S E R V I C E B U L L E T I N

FUJI HEAVY INDUSTRIES

NO. FAS-014

1. SUBJECT ; Removal of VHF speaker to forward position.
2. AIRCRAFT AFFECTED : FA-200 Serial No. 12 through 101 airplanes.
3. PRIORITY : Optional.
4. REASON : In order to improve the sound of VHF speaker.
5. DESCRIPTION : Remove the VHF speaker from ceiling of rear seat to the lower position of instrument panel.
6. ACCOMPLISHMENT : At any time.
7. APPROVAL : Not applicable.
8. PARTS REQUIRED : Parts will be supplied as a service kit (200-590502) which include the parts as follows.

INSTALLATION

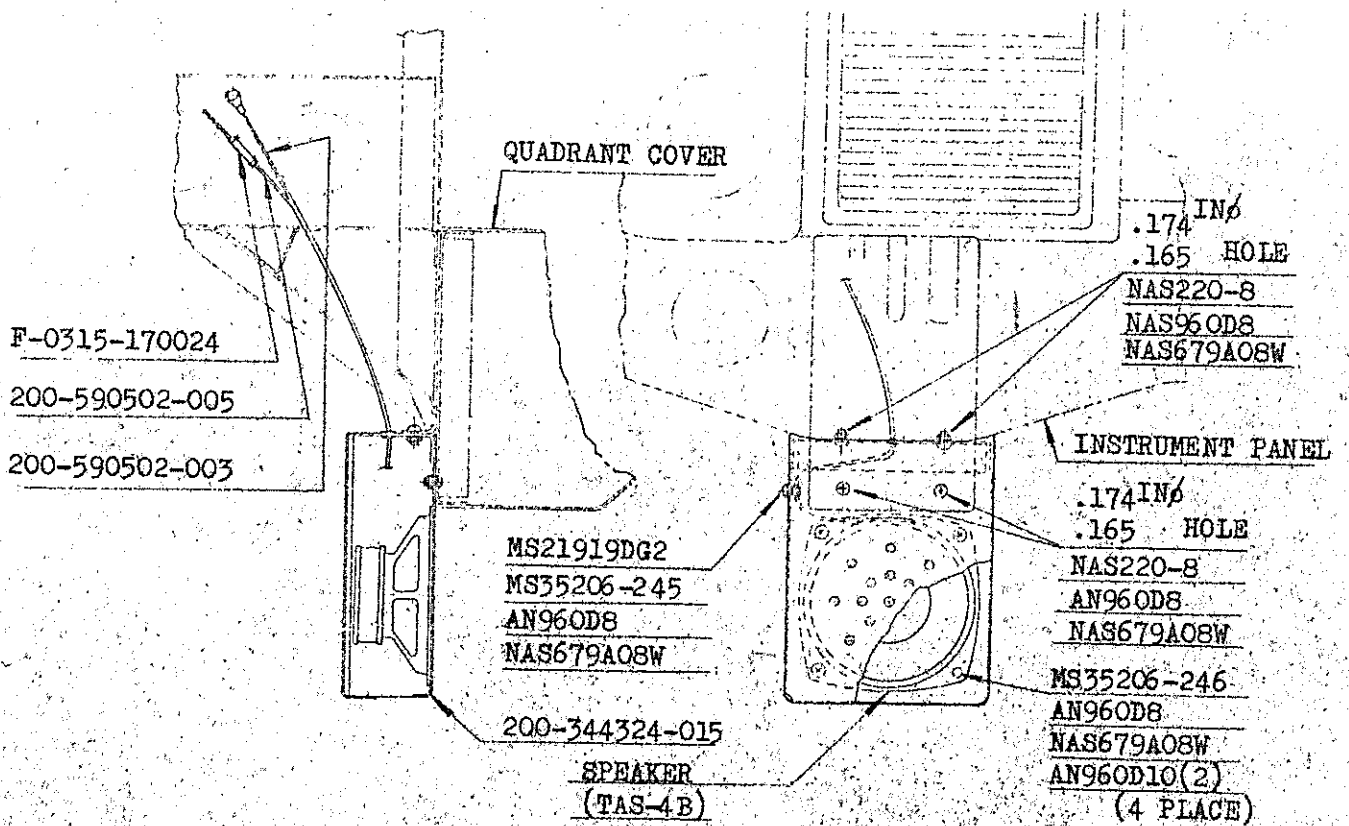
9. SPECIAL TOOLS : Nothing.
10. WEIGHT AND BALANCE: No change.
11. REFERENCE : Nothing.
12. MANPOWER : 5 MH.
13. WORK PROCEDURE :
1. Remove the VHF speaker from the ceiling of rear seats.
 2. Remove the cover of engine quadrant.
 3. Fix the speaker bracket (200-344324-015) on the lower parts of instrument panel.
 4. Install the speaker (TAS-4B) on the bracket.
 5. Fix the cover on the engine quadrant.
 6. Conduct the compass correction.

WIRING DIAGRAM

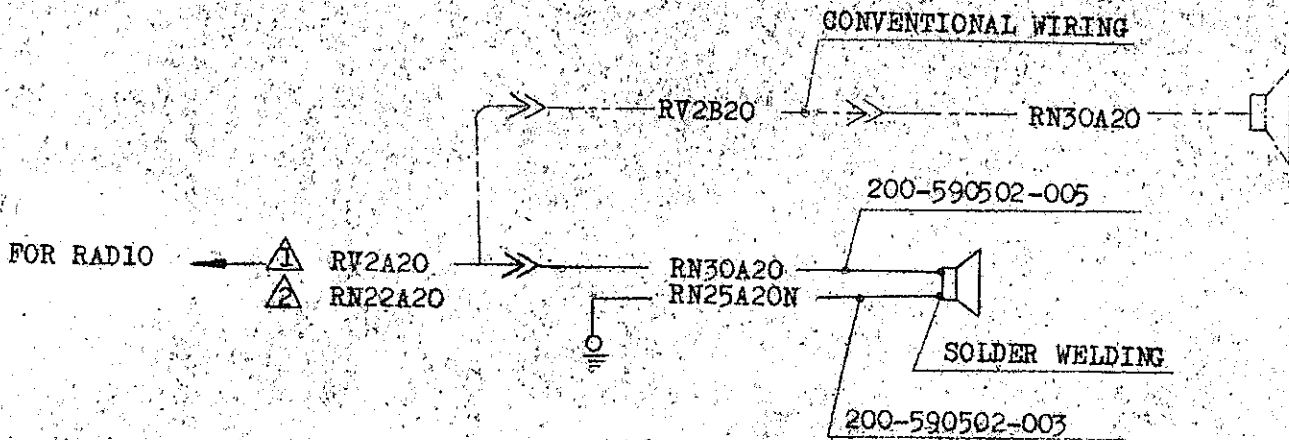
- △ MAR-6Y COMMUNICATION RADIO
- △ KX-160 COMMUNICATION RADIO
